Re: 485 Monterey Avenue  
Zoning Change Application: **Z-15-001**  
Arch & Site Application: **S-15-018**

Studio 3 Design has reviewed the above referenced planning comments (dated 8.18.2015). The following is an itemized response letter addressing the comments.

## ARBORIST REPORT

485 Monterey Avenue  
Los Gatos, California

## TREE MAP

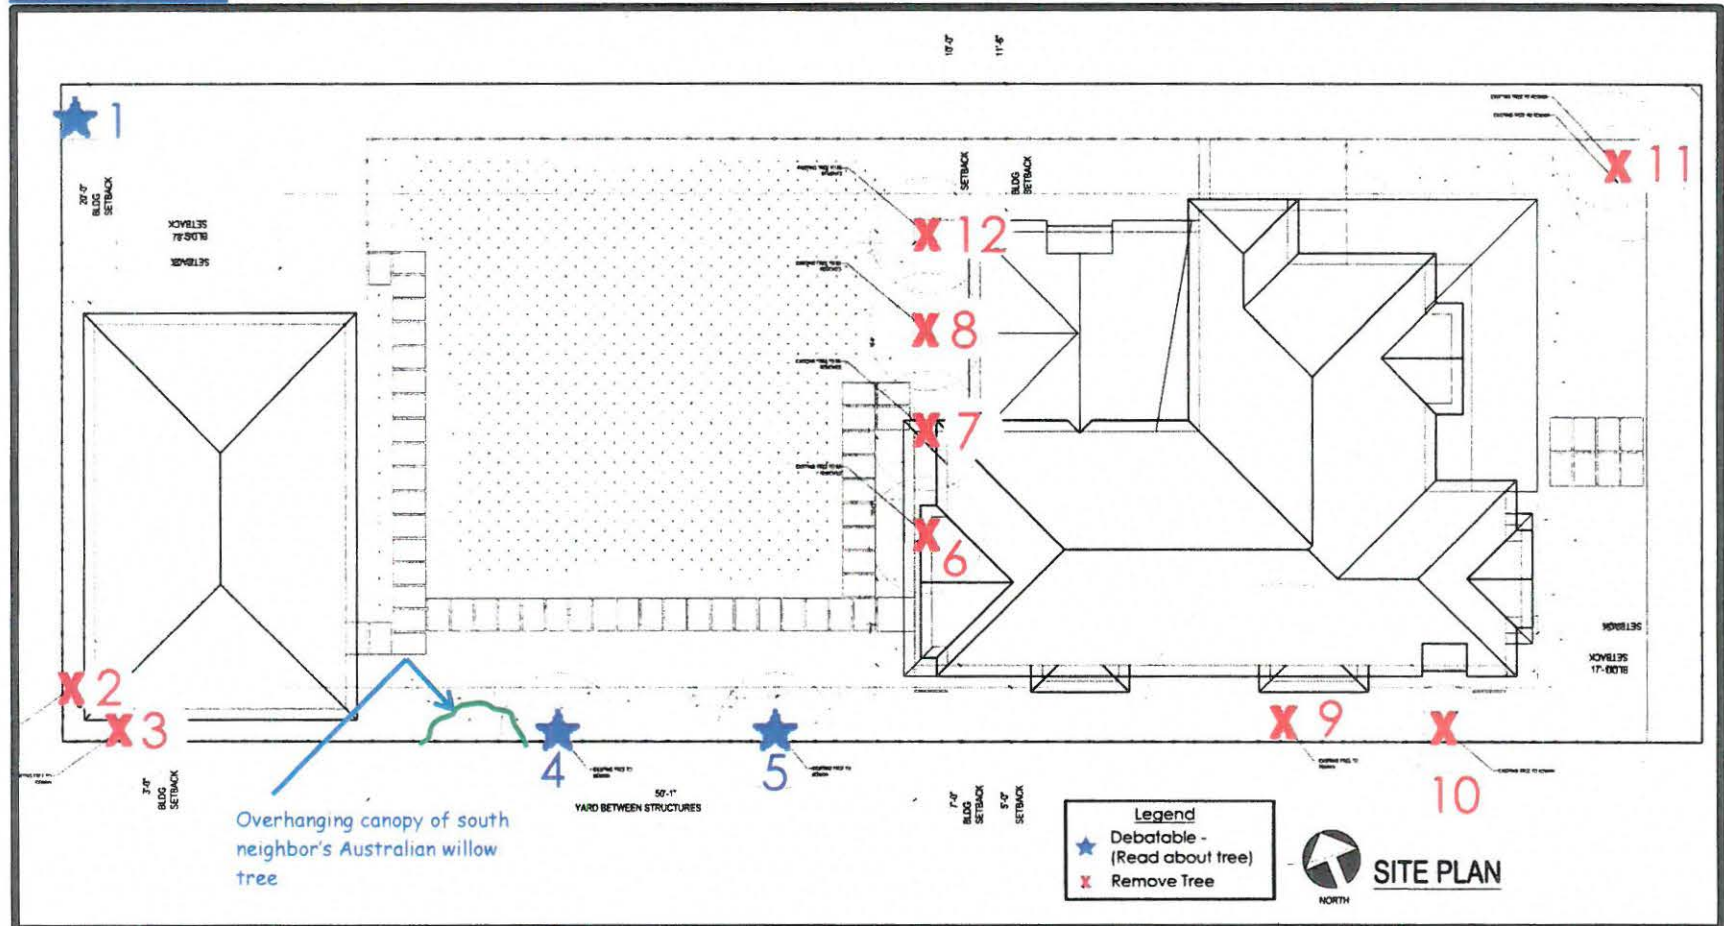
Only four of the existing trees (**#6, 7, 8 and 12**) are shown to be removed on the site plan, but in reality all but three trees (**#1, 4 and 5**) will need to be removed. Existing tree trunks are shown on the plans, but these trunks are often just a few feet away from a proposed building. From both a root and canopy preservation standpoint, this will not work. A summary of all trees is provided in Table 1 on page 3 and a more detailed description of all trees is provided in the Complete Tree Table on page 6. This table also lists recommended root protection distances in case the site layout will be redesigned to save some of the trees. The best tree on site is large **evergreen ash tree #9**, and this is the only tree that I would consider redesigning the project to save. Most of the other trees are not worth redesigning around. In the long term it will be better to remove these trees and replace them with more sustainable new landscaping; most importantly drought tolerant landscaping.

1. Existing trees to be saved or removed should be numbered on all site-based plans to match the tree tag numbers that are used in this arborist report.

**The protection of neighboring trees:**

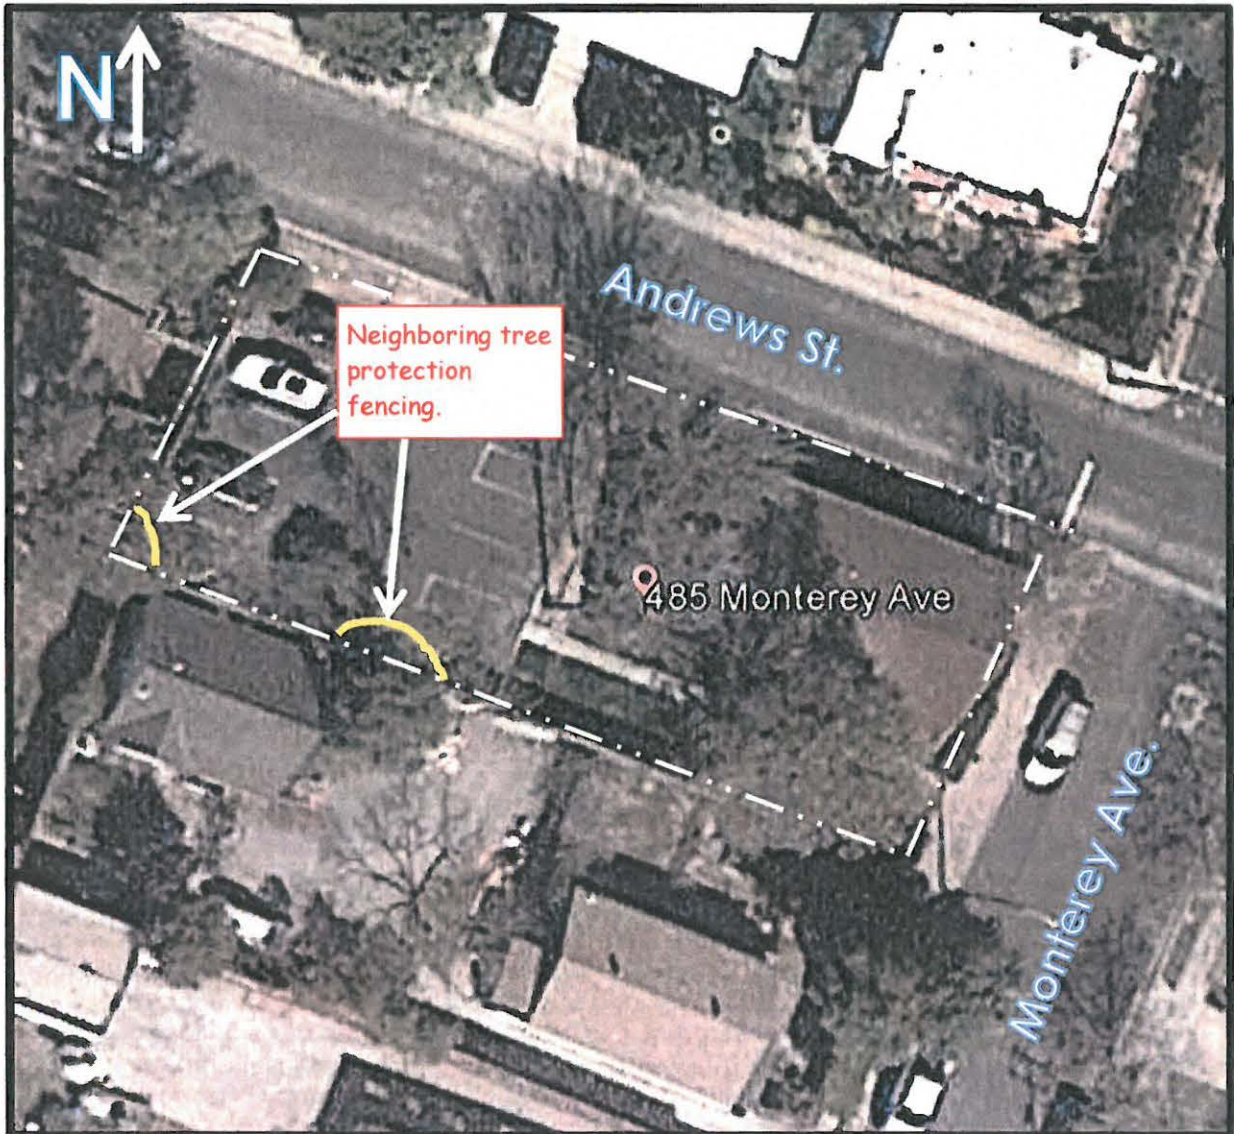
Neighboring tree canopies are not accurately shown on the project plans. It is easier to see these trees on an aerial map of the site, which I have included on page 3. Tree protection fencing and signage, as per the Town of Los Gatos Tree Protection Ordinance, should be placed at the edge of the dripline of any neighboring tree canopies overhanging the site. If the contractor feels that it is not possible to place the tree protection fencing at this location, then the Town should be contacted so that they may send their consulting arborist to meet with the architect and/or contractor at the site to agree upon an alternative solution. I have drawn in tentative tree protection fencing locations for these neighboring trees on the aerial map on page 2.

Likewise there should be no soil disturbance on the project site within the dripline of the tree or a minimum of 6 feet from the edge of the trunk of the neighboring tree. This means that some of the drainage running along the perimeter of the property must be moved farther from the fenceline. If the contractor feels that this is not possible, then the Town should be contacted so that they may send their consulting arborist to meet with the architect and/or contractor at the site to agree upon an alternate solution.
